**NSLPP MEETING HELD ON 19/07/2023**

**ADDRESS/WARD:** 601 Pacific Highway, St Leonards

**PROPOSAL No:** PP2/23

**DATE OF REPORT:** 26 June 2023

**FIGURE 14: Indicative Section Plan (Applicant’s Urban Design Report, p.80). Note. The maximum building height has been measured from the lowest point of the site, which is RL 87.5 as noted on the Ground Level Floor Plan on p.65 and 66 of the Applicant’s Urban Design Report.**

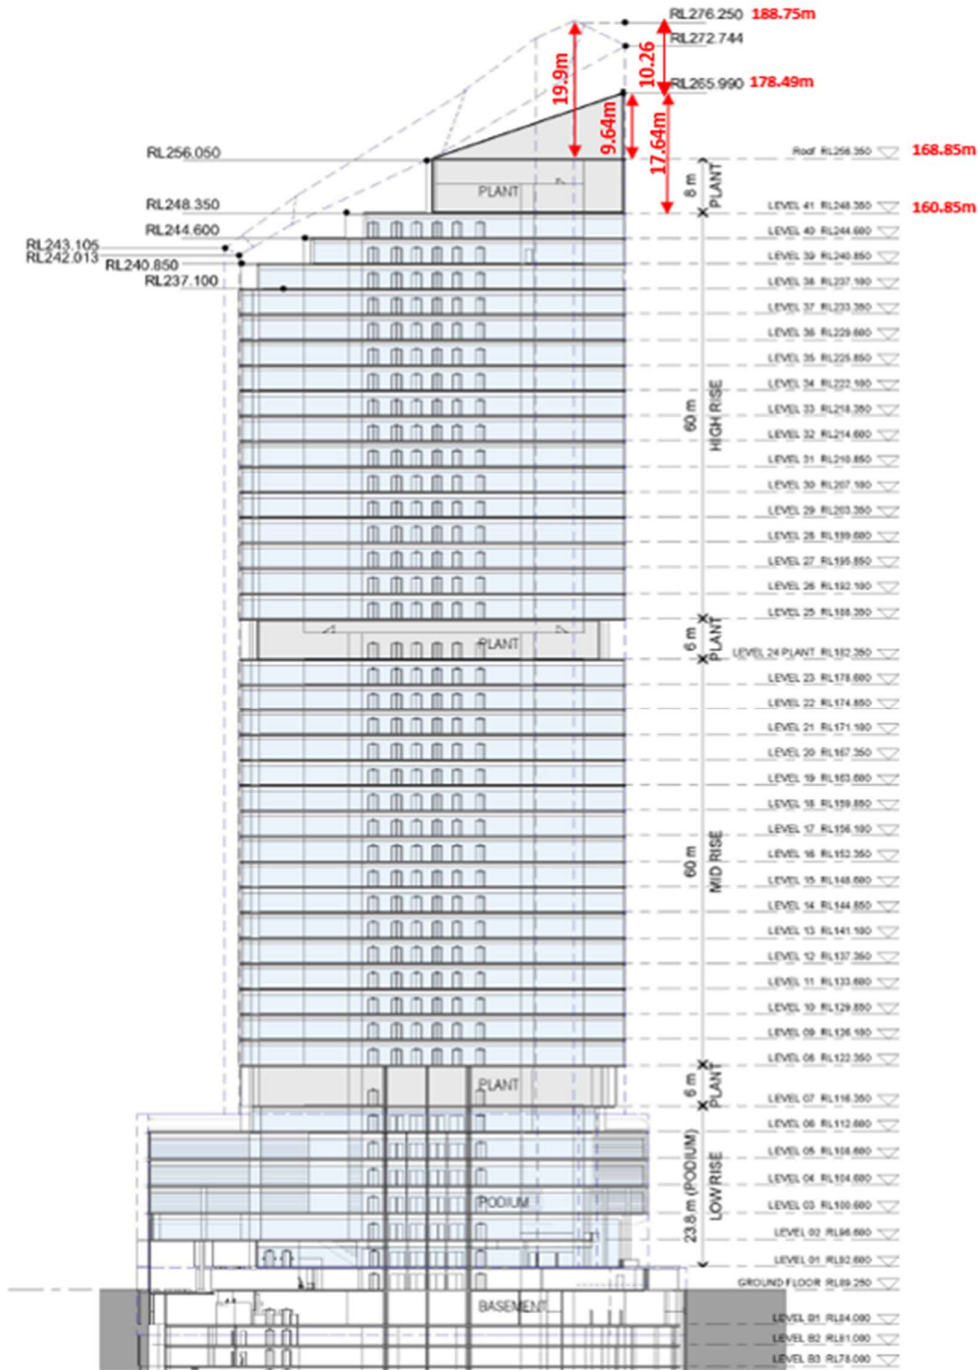
Figure 14 illustrates the Applicant’s indicative concept design with a building height of RL265.990 (equivalent to 178.49m) measured to the top of the roof, inclusive of an 8m high plant room structure and 9.64m clearance above the top-level plant room. An additional allowance of 10.26m is also sought above RL 265.990 for what appears to be for the purposes of an architectural roof feature, which represents a significant height increase above the 42 storey height building height limit under the 2036 Plan.

Despite the above, it is still unclear why the Applicant has requested an additional 9.64m above the 8m top level plant room, as well as an additional 10.26m for what appears to be for the purposes of an architectural roof feature. Refer to Figure 14 above.

As such, it is recommended that the additional proposed 19.9m above the plant room level be reduced to 3m, to allow for some flexibility in building design whilst ensuring the final proposed building is no more than 42 storeys in height. Any additional height for architectural roof features may be considered later at a DA stage under a Clause 4.6 Variation to Development Standards or Clause 5.6 Architectural Roof Features of *NSLEP 2013*.

**FIGURE 15: Indicative Ground Floor Plan (Applicant's Urban Design Report, p.66)**

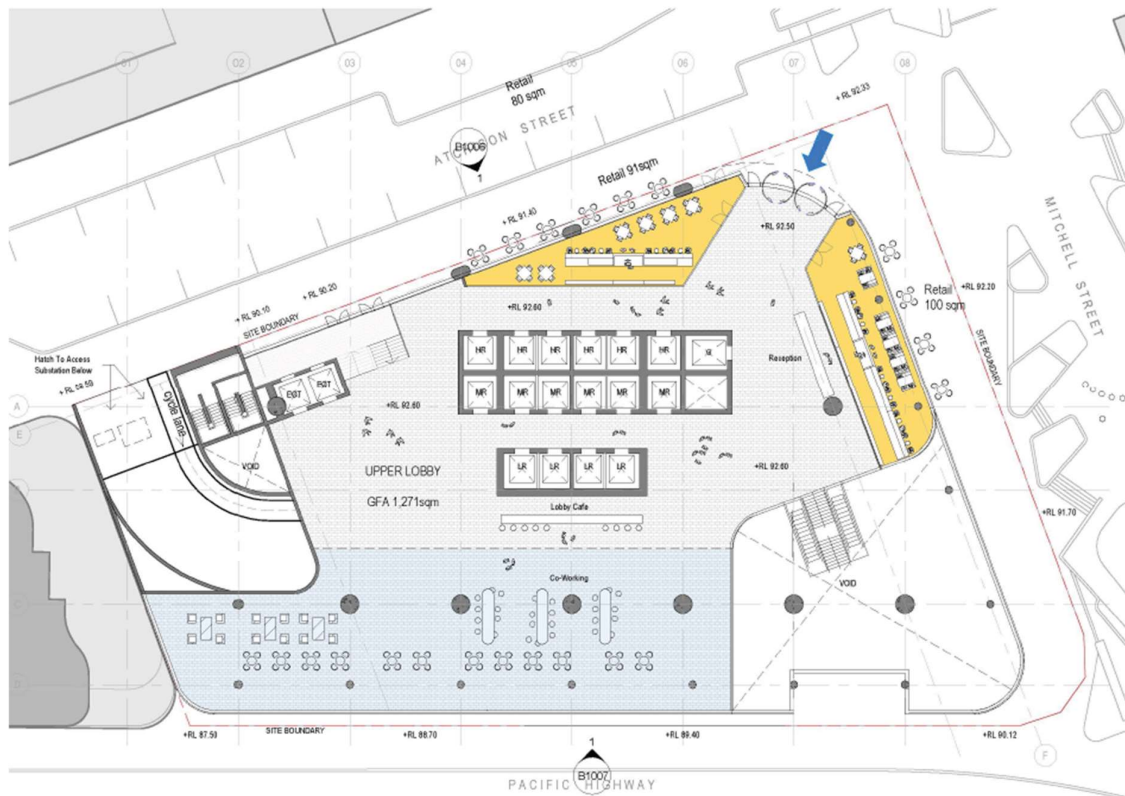
As illustrated at Figure 15 below, there is an approximate 2.6m fall from east to west along the Pacific Highway frontage; 3.7m fall from east to west along the Atchison Street frontage; and 2.2m fall from north to south along the Mitchell Street frontage.

**FIGURE 16: South Elevation Plans – Pacific Highway (Applicant's Pre-lodgement Response, pg.5)**

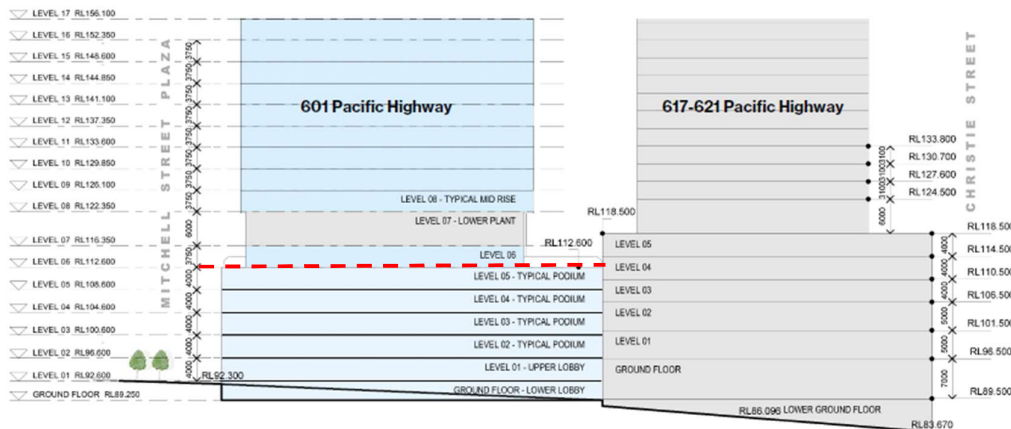
The Applicant's supporting concept design presents a 5-storey podium to Mitchell Street Plaza frontage and a 6-storey podium along the Pacific Highway and Atchison Street frontages. This does not comply with the *2036 Plan* or *NSDCP 2013* (refer to Figure 16) and will result in an over scaled podium. Additionally, the proposed floor to heights for the podium (3.35m-7.35m for the ground level and 4m for Levels 1-5) are greater than required and could be reduced.

The Applicant's justification for the proposed podium height is that it aligns with the podium height of the proposed adjoining building at 617-621 Pacific Highway and will provide a consistent podium height across the block. However, the podium height for 617 Pacific Highway is also considered excessive for the required 6 storeys under the *NSDCP 2013*. Further, the 617 Pacific Highway proposal is a concept design only and has not been approved. The 2036 Plan does not nominate a maximum street wall height for the 617-621 Pacific Highway. The *NSDCP 2013*, however requires a maximum 6 storey podium height, which accounts for the continued slope along that falls to the west.

It is recommended that the proposal be redesigned to provide a maximum podium height of 4 storeys in accordance with the *NSDCP*. A podium height of 4 storeys (approximately 15.6m-17.8m) to Mitchell Street is recommended that increases to a maximum of 5 storeys along the Atchison Street and Pacific Highway frontages, following the slope of the site (i.e. up to approximately 19.3m for 5 storeys along Atchison Street and 20.4m for 5 storeys along Pacific Highway when taking into account the ground level changes). These heights assume a ground floor level of 4.5m-6.7m and 3.7m for commercial levels above.
